**PLANNED UNIT DEVELOPMENT
STAFF REPORT****Date: June 16, 2016****DEVELOPMENT NAME**

Matthew M. Brooks

LOCATION110 South University Boulevard
(West side of South University Boulevard, 2/10 mile ±
South of Old Shell Road).**CITY COUNCIL
DISTRICT**

CONTEMPLATED USEPlanned Unit Development Approval to amend a
previously approved Planned Unit Development to allow
shared access between multiple lots and multiple buildings
on multiple lots.**TIME SCHEDULE
FOR DEVELOPMENT**

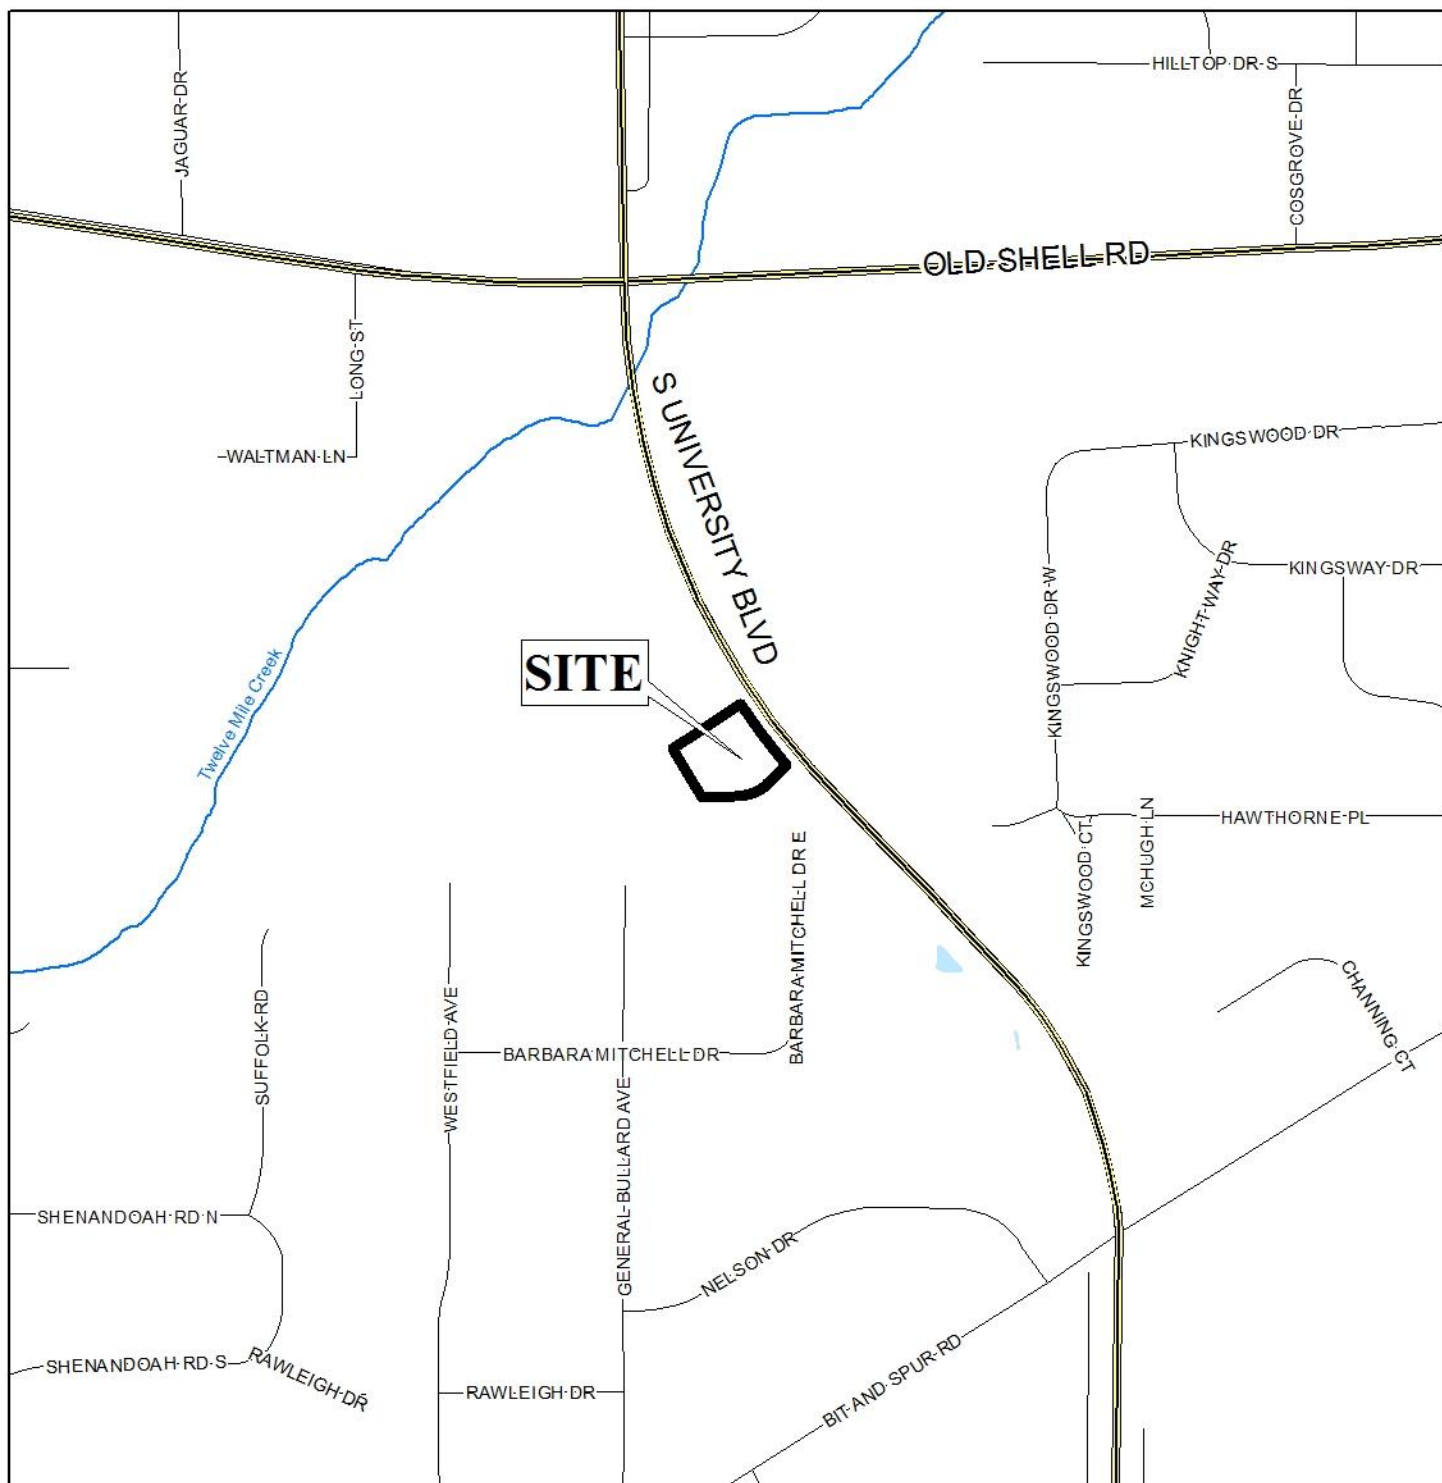
The site plan depicts a compliant number of frontage trees along South University Boulevard, however the required amount of parking trees appear to be missing. Staff is aware that there is an existing tree given preservation status by Urban Forestry as part of an approval at the January 6, 2011 Planning Commission meeting that will remain on the site, but is unsure if the applicant proposes on using the existing tree for tree credits for the site. If the existing tree is to be used for tree credits, the species and size of the tree will be required on the landscape plan submitted with the land disturbance permit.

There is also a note on the site plan that implies that there is 8,822 square feet of green space. However, there are no calculations provided to illustrate the total and frontage landscaping required and provided. The site plan must be in full compliance with the tree planting and landscaping requirements per Section 64-4.E of the Zoning Ordinance. The site plan should be revised to illustrate total amount of landscaping and frontage landscaping.

The site plan depicts curbing along the entire site except where the 8 parking spaces abut the sidewalk entrance to the restaurant. The site plan should be revised to depict curbing or bumper stops to prevent cars from encroaching onto the sidewalk.

The site plan illustrates the dumpster, but does not illustrate the provision of a dumpster buffering (and connection to sanitary sewer); therefore, it should be noted that dumpsters must meet the buffer, connection to sanitary sewer, and setback requirements of the Zoning Ordinance as well as be enclosed on 3 sides.

Due to the fact the site is adjacent to residentially used property, compliance Section 64-4.D.1. with the buffering requirements along the rear of the site will be required.

Planned Unit Development: Based upon the revised PUD site plan, this application is recommended for Approval, subject to the following:

- 1) retention of the 25' minimum building setback lines;

- 2) revision of the site plan to illustrate a residential buffer compliant with Section 64-4.D.1. of the Zoning Ordinance along the rear property line;

- 3) revision of the site plan to depict curbing or bumper stops or wheel stops to prevent cars from encroaching onto the sidewalk or landscape areas;
- 4) compliance with Sections 64-4.A.2., 64-6.A.3.c., and 64-6.A.8. of the Zoning Ordinance regarding lighting;

- 5) submission of a photometric plan at the time of submittal of a building permit;
- 6) full tree and landscaping compliance per Section 64-4.E of the Zoning Ordinance;

- 7) revision of the site plan to depict the required landscape areas with calculations reflecting total landscaping and total frontage landscaping;
- 8) dumpsters must be in full compliance with Section 64-4.D.9;
